**PRELIMINARY PLAN OF SUBDIVISION**  
4-20040

**WEST HYATTSVILLE**  
2700 HAMILTON STREET, HYATTSVILLE, MD 20782

Re: West Hyattsville  
PPS-20040  
Soltesz, No.: 07060600

In response to the comments generated at the SDRC meeting July 23, 2021, we offer the following responses:

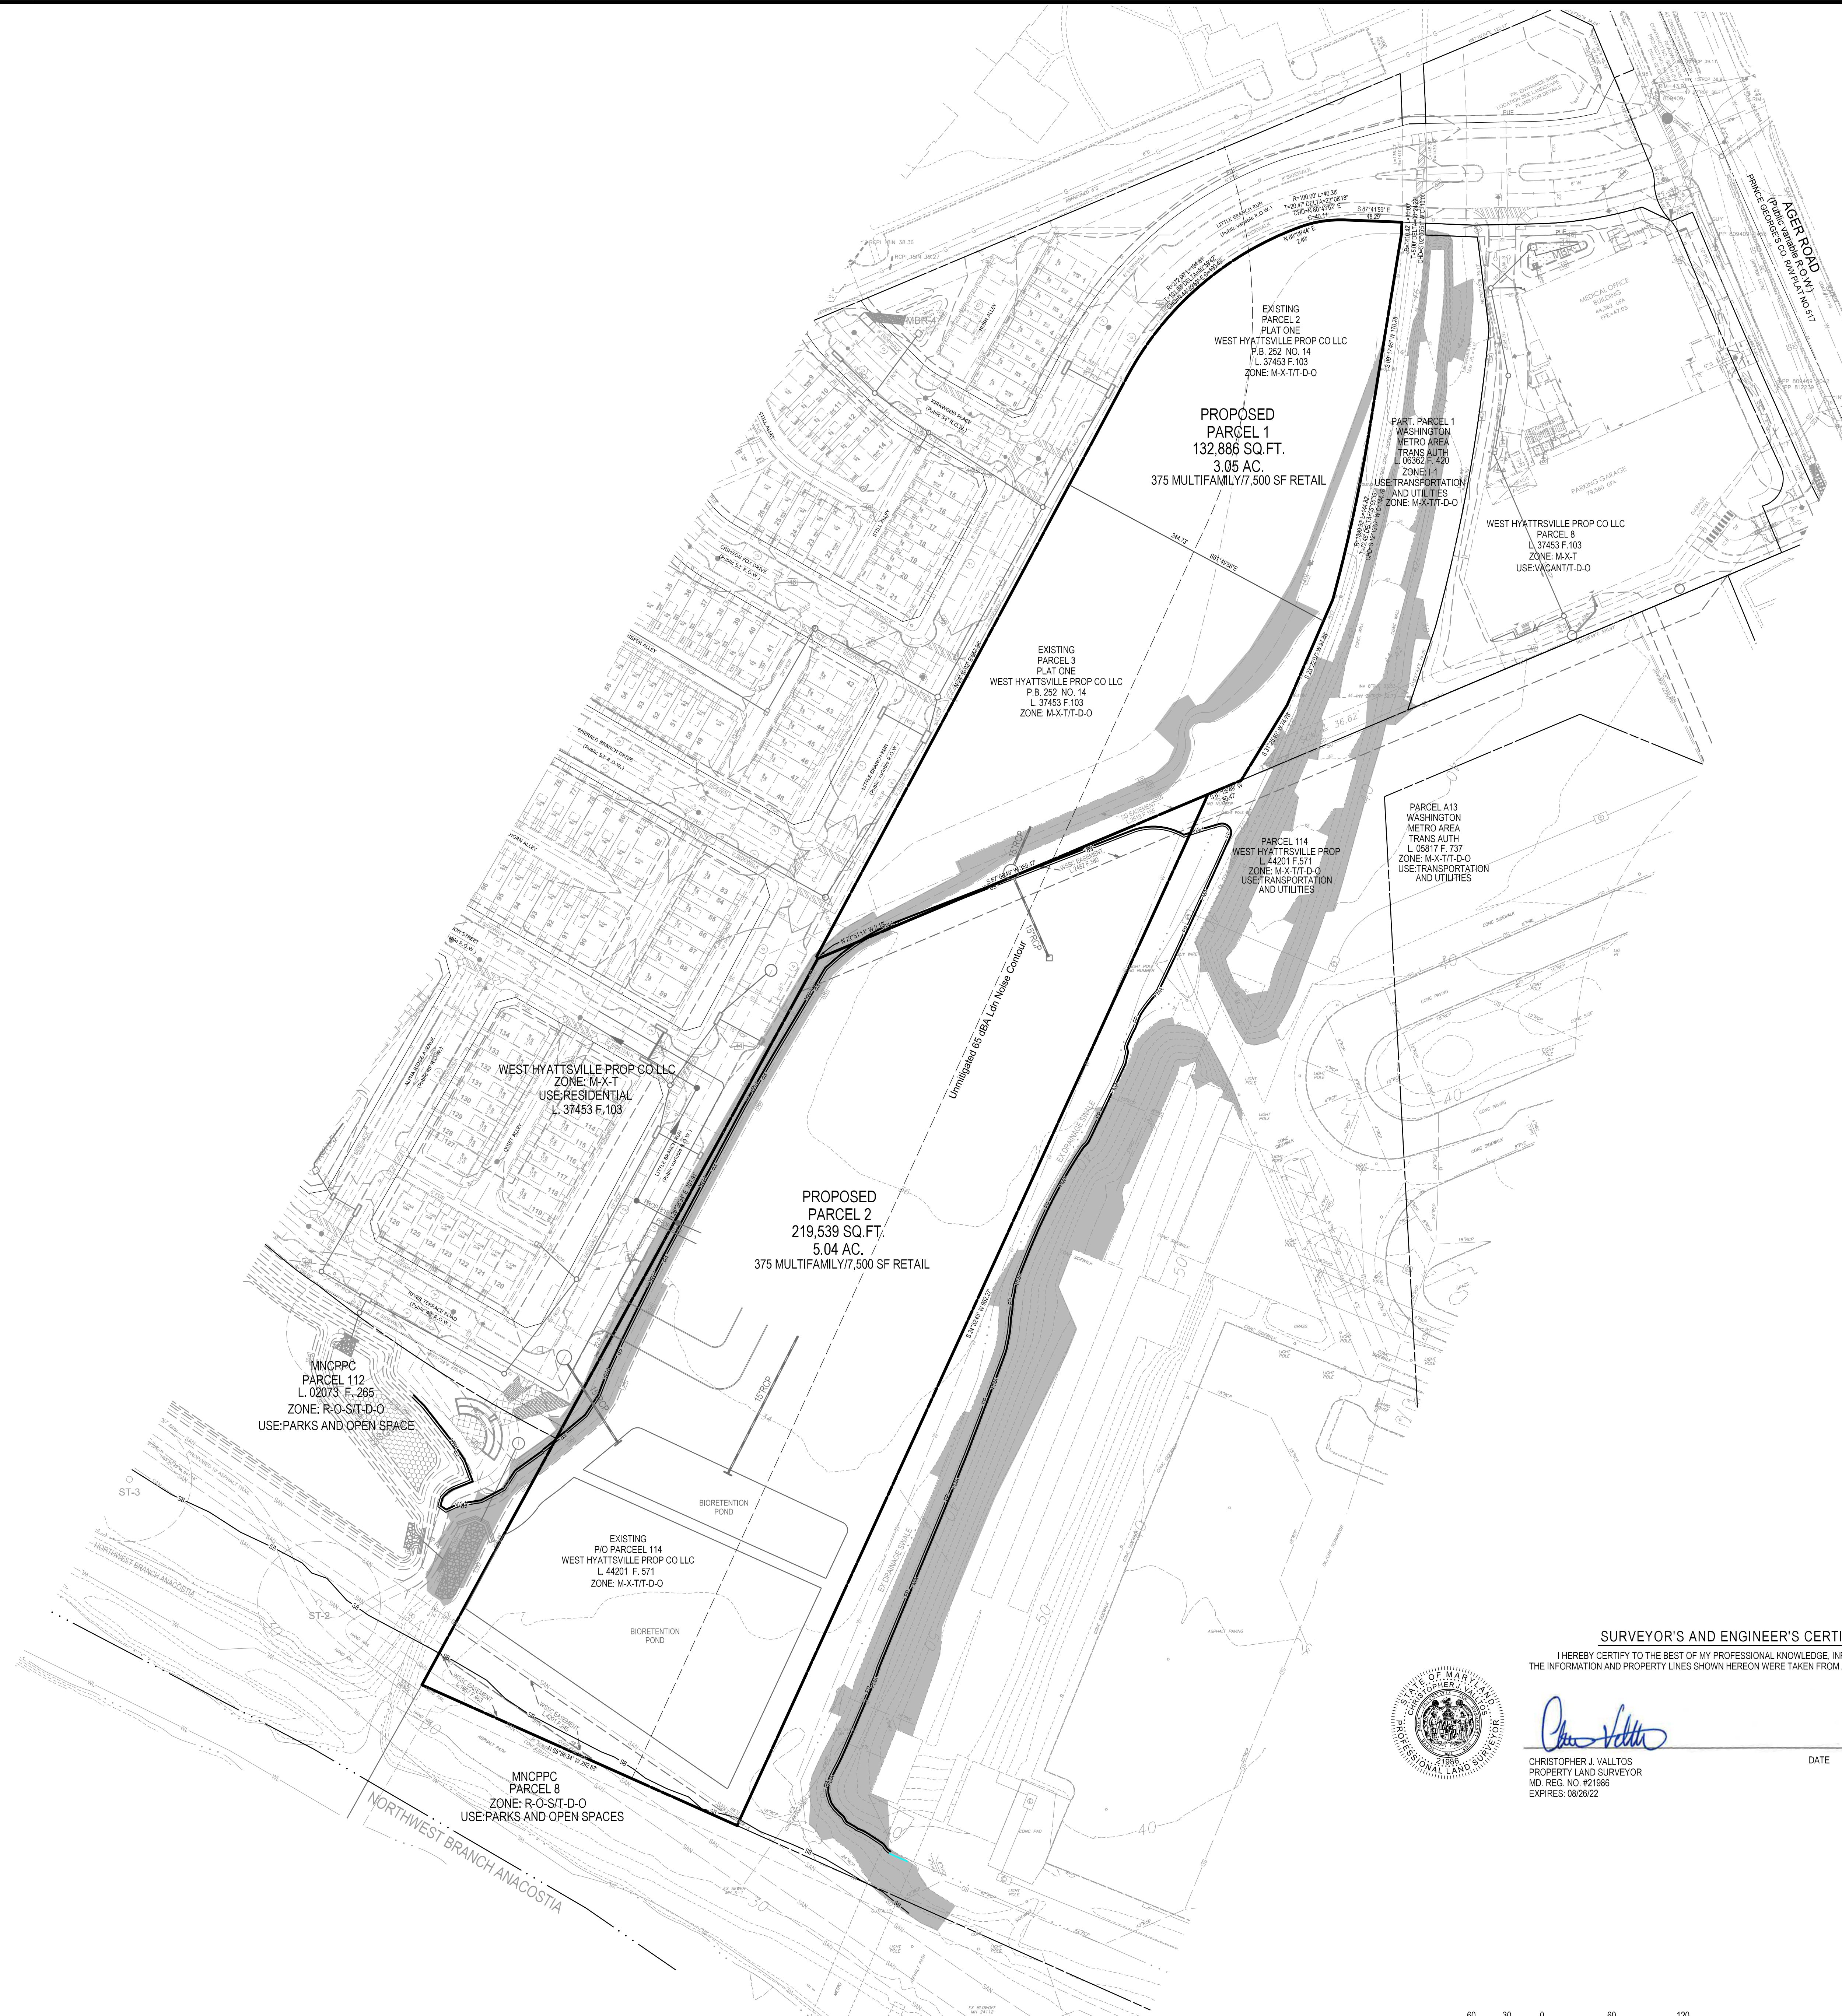
Comment 1: Label the noise line as unmitigated 65 dBA Ldn noise contour

Comment 2: Revise General Note 1 to list 'Existing Part of Parcel 114' instead of 'Existing Parcel 114'.

Comment 3: Correct spelling of 'subdivision' in General Note 4.

Comment 4: Correct reference to PPS 4-05145 in General Note 5.

Comment 5: Revise General Note 6 to correct the net acreage after accounting for area within the 100-year floodplain.

Comment 6: Add T-D-O zoning to General Note 11. Provide existing use for Parcel 1 (existing Parcels 2 and 3).

**Response: The noise line has been labeled.**

**Response: The note has been revised.**

**Response: The spelling has been corrected.**

**Response: The reference has been corrected.**

**Response: The note has been revised.**

- Response:** **The note has been revised.**  
Comment 7: Revise General Note 21 to provide approval date for SWM Concept Plan.
- Response:** **The SWM Concept Plan is still under review.**  
Comment 8: Complete General Note 27 with the TCP1 number.
- Response:** **The note has been revised.**  
Comment 9: Revise the Vicinity Map to increase legibility of police, fire & EMS locations.
- Response:** **The vicinity map has been revised.**  
Comment 10: Add PPS 4-20040 to the title block in big and bold text.
- Response:** **The label has been added.**  
Comment 11: Provide copies of all easements and rights-of-way on or abutting the property, in accordance with the checklist.
- Response:** **The easement documents have been provided.**  
Comment 12: Show location of existing and proposed storm drains and stormwater facilities.
- Response:** **The storm drains have been shown.**
